**AMENDMENTS TO THE DRAWINGS**

Application No.: 10/717,974

Amdt. dated March 3, 2006

FIG. 5

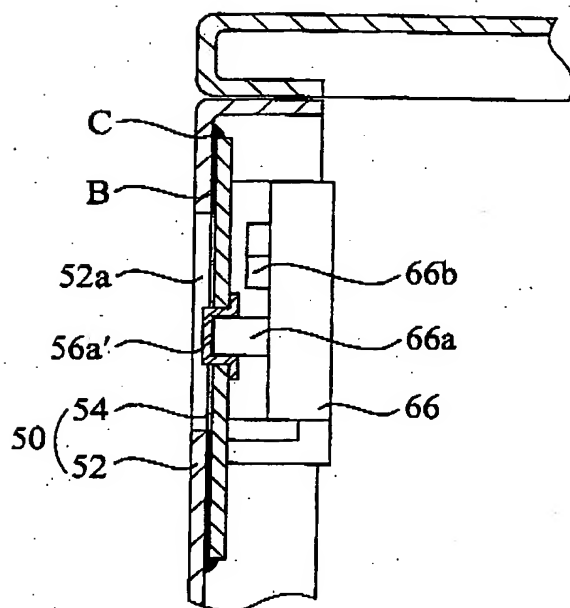
With respect to Fig. 5, the reference label “ **56a’** ” has been amended to “ **66a’** ”.

With respect to Fig. 6, the reference line associated with “ **66a’** ” has been corrected. In addition, the reference line associated with “ **54h** ” has been corrected.

As an initial matter, the Examiner objected to the drawings and asserted that the proposed reference corrections may not be accurate because Figure 5 and Figure 6 refer to controls **66a** and display **66b**, which are depicted at different elevations in Figure 5 than in Figure 6.

Applicants respectfully request withdrawal of the objection to the drawings. More specifically, Applicants have amended the drawings, particularly the reference line associated with reference label **66a'**. Accordingly, favorable consideration and approval of the drawings is respectfully requested.
